APPENDIX A – Response to Government Agencies and Organisations

State Significant Development SSDA 8669

St Aloysius' College

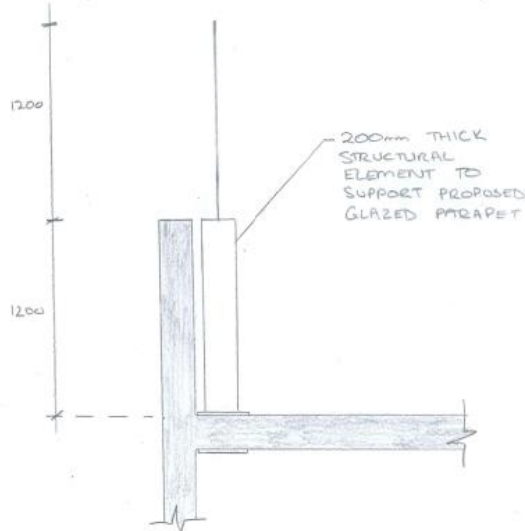
48 UPPER PITT STREET – SP 1036, PREPARED BY PAUL BERKEMEIER ARCHITECTS	
VIEW IMPACTS	
The View Impact Assessment takes photos from Unit 27, located on the 5th floors, however, it is considered the view impact from units on the 2nd and 3rd floors is more significant, particularly the impact of the proposed	Figure 4 and Figure 5, taken from Levels 2 and 3, 48 Upper Pitt Street, illustrates the existing and proposed view. It is evident the proposed development will in fact improve the current view, with the removal of the existing stairwell. The acoustic barrier sits below the parapet of the North-East Wing and therefore will not obstruct the views from units on Levels two (2) and three (3) of 48 Upper Pitt Street.

ISSUES RAISED BY AGENCIES AND ORGANISATIONS	PROPONENT'S RESPONSE
balustrade and screen to the south and east edges of the roof top play area.	 Figure 4 View from Unit 6, Level 2, 48 Upper Pitt Street  Figure 5 View from Unit 13, Level 3, 48 Upper Pitt Street
The drawings of the new East Wing on Upper Pitt Street appear to show an increase in the parapet height from the existing RL43.21 to RL43.49, an increase of 0.28m. Similarly, the new façade element above the main entrance appears to be raised from existing RL46.29 to	The parapet height of the new north-east wing has been lowered by 270mm to reflect the existing heights, presenting an RL 43.22. Demonstrated in the VIA (Appendix E) prepared, and amended by RobertsDay, the existing views from 2nd and 3rd Floor units will be retained, if not improved, with the removal of the existing stairwell. It is noted, the units

ISSUES RAISED BY AGENCIES AND ORGANISATIONS	PROPONENT'S RESPONSE
RL46.96, an increase of 0.67m. Both changes appear to be quite unnecessary and would have a severe impact on views from the 2nd floor units.	located on the 2nd floor sit below the current building height, and therefore no change to the current view will occur, after the removal of the stairwell.
Unclear on the exact height of the proposed roof-top plant enclosure on the new East-Wing.	Refer to revised Architectural Drawings prepared by PMDL (Appendix C).
Some of the parapet heights are not entirely clear, or may contain errors. For example, Section 3 on Sheet DAU301 shows parapet to the new East Wing as RL46.64 rather than the intended RL43.40 for that part of the Section.	Refer to revised Architectural Drawings prepared by PMDL (Appendix C).
NOISE	
Concern over the noise from the rooftop. Any use of amplified sound, voice or music, would exacerbate this problem and should not be permitted. The hours of use should be restricted to normal school hours and be listed in the consent. Any out-of-hours use, for example New Years Eve or Australia Day, may be considered but must be listed in the Consent.	The implementation of an acoustic barrier of 2.4m (noise models taken from 2.1m), around the perimeter of the proposed rooftop terrace of the infill building on the main campus, will in fact reduce the current school noise impacts on the most highly sensitive receivers. Refer to Appendix K. The hours of use for rooftop terrace will be guided by a future Plan of Management, prepared by St Aloysius' College. However, it would be reasonable the school related events currently held in the quadrangle will be conducted on the rooftop terrace, other than cadets. Notwithstanding, a preliminary Schedule of Uses, and the like, has been prepared and accompanies this application as Appendix P.
